Subject: RE: 074685 Plains-Darr Angell #2 Groundwater Remediation Site (1RP 4679) Request to Backfill Remediated

Release Area

PLAINS PIPELINE L.P.
LEA COUNTY, NEW MEXICO
DARR ANGELL No.2
SITE DETAIL AND
ANALYTICAL RESULTS MAP

FIGURE 3

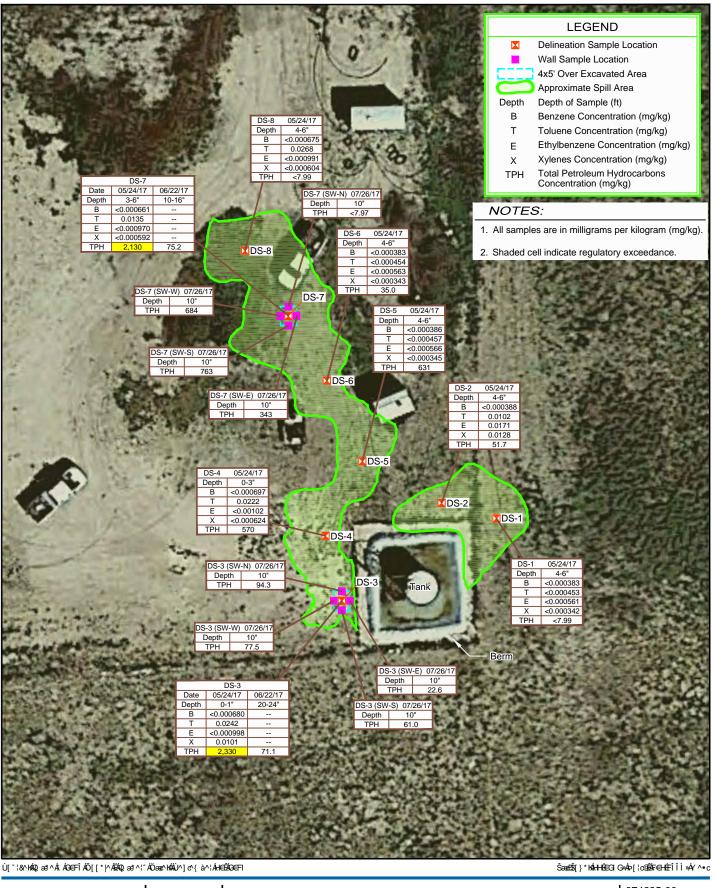
Per your email dated July 25, 2017, 4 confirmatory sidewall samples were collected on July 27, 2017, from each of the over excavated areas at DS-3 and DS-7 locations and confirmation bottom samples were previously collected from the same areas on June 22, 2017. Review of all delineation and confirmation sample results indicates BTEX and TPH concentrations are below RRAL's determined for the Site and GHD requests the NMOCD's permissions to backfill the scraped/excavated areas. The reason for requesting approval to backfill at this time is so that Plains' groundwater remediation system can be brought back into operation shortly after backfilling & restoration activities are completed. Attached is Figure 3 which depicts the scraped/over excavated areas, delineation & confirmation sample locations, collection dates, depths, and analytical results.

Thank you for following-up with 1RP-4679. After reviewing the photos, confirmatory laboratory samples for the sidewalls of DS-3 and DS-7 locations are still necessary to verify that TPH remains within permissible levels. Please be advised that NMOCD requires confirmatory bottom and sidewall samples for closure of any RP.

Thank you for the provided data. NMOCD grants backfill approval for the excavated areas pertaining to 1RP-4679. NMOCD looks forward to the remediation report with final C-141 and all relevant documentation for closure.
